Federal Register

[Docket No. FAA-2020-0098; Product Identifier 2020-NM-011-AD; Amendment 39-19844; AD 2020-03-20]

Airworthiness Directives; The Boeing Company Airplanes

ACTION: Final rule; request for comments.

Figure 2 to paragraph (g) – AFM – Limitations or Certificate Limitations continued

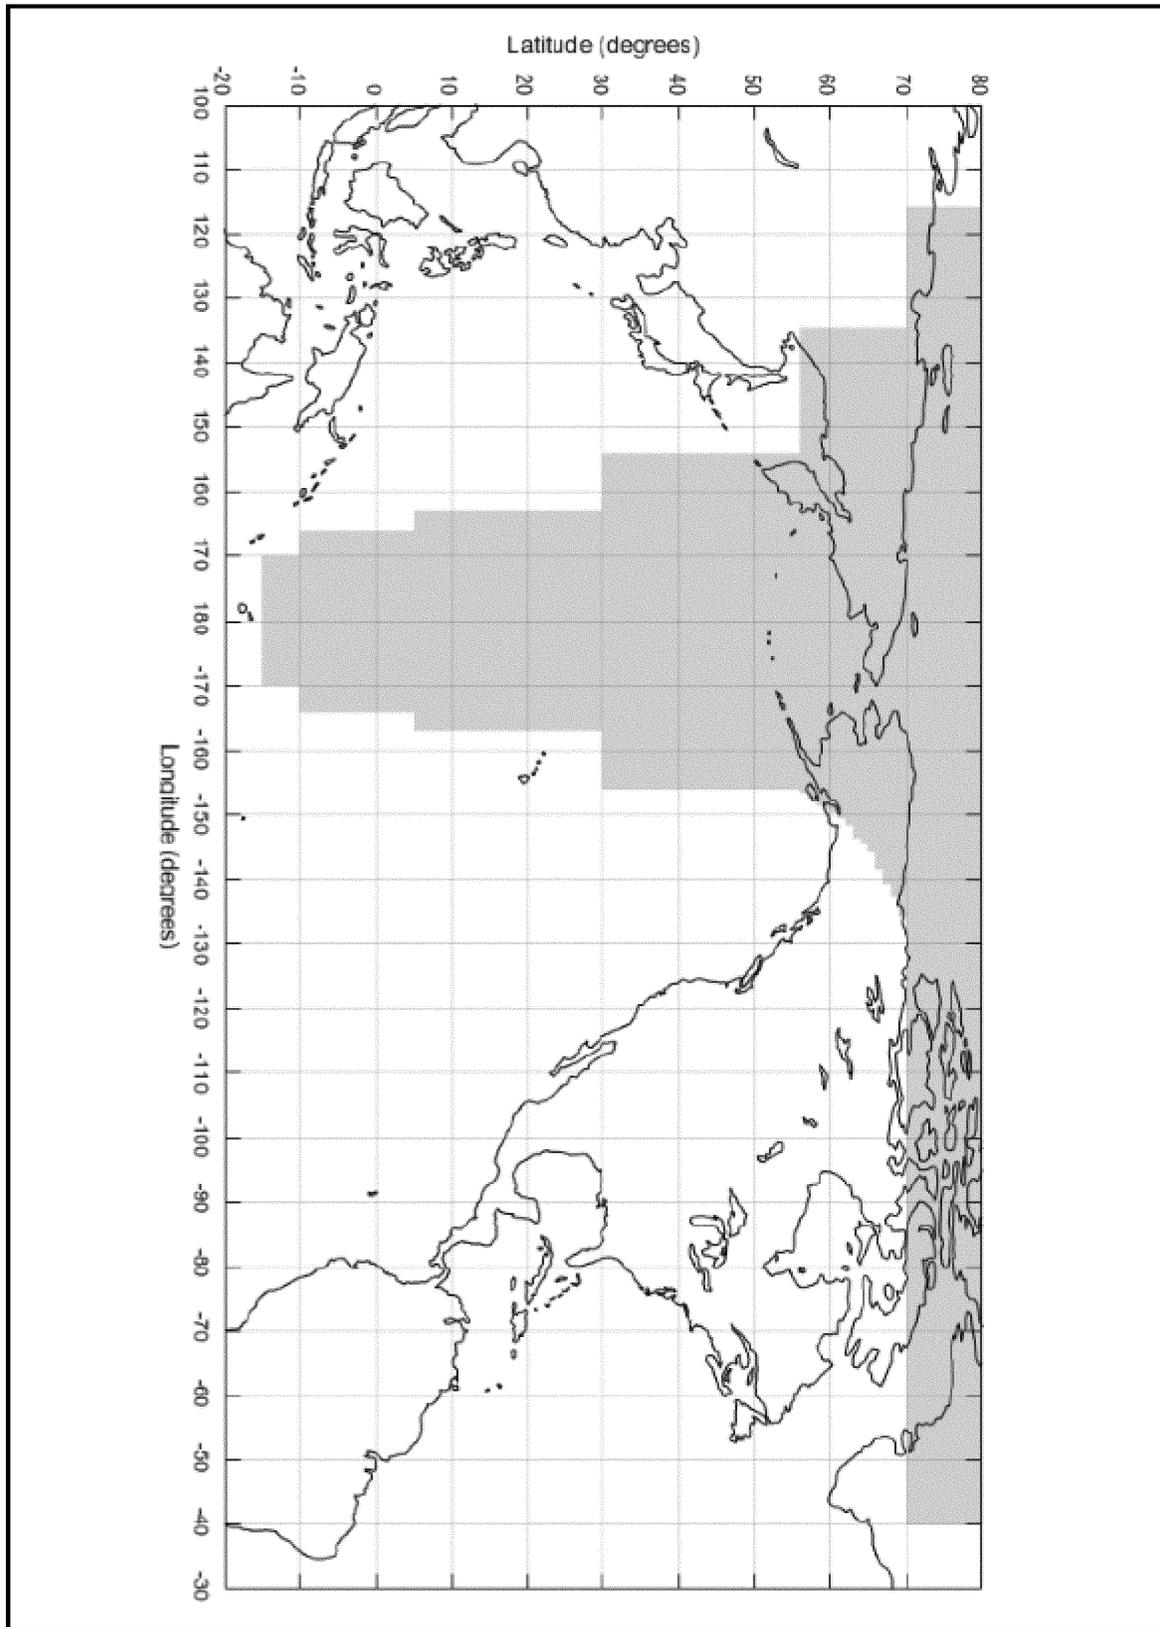
Operations that require less than 0.3 RNP (For example, 0.1, 0.11, 0.15, etc.) in the region identified below are prohibited with GLU-2100 OPS software number COL4D-0087-0002, COL4E-0087-0001, COL48-0087-0700, or COL49-0087-0701 installed.

Exception: Anchorage (PANC) approach procedures that allow less than RNP 0.3 are authorized provided the instructions outlined in the Electronics – Global Landing Unit Section of Normal Procedures Chapter are followed.

Note: Currently, Fairbanks (PAFA) and Anchorage (PANC) are the only airports in the region with an RNP approach that requires better than 0.3 nmi performance.

Region bounded by the following coordinates:

This AD requires revising the existing airplane flight manual to include a limitation to prohibit operations that require less than 0.3 RNP within a specified area for airplanes having a certain MMR with certain software installed.
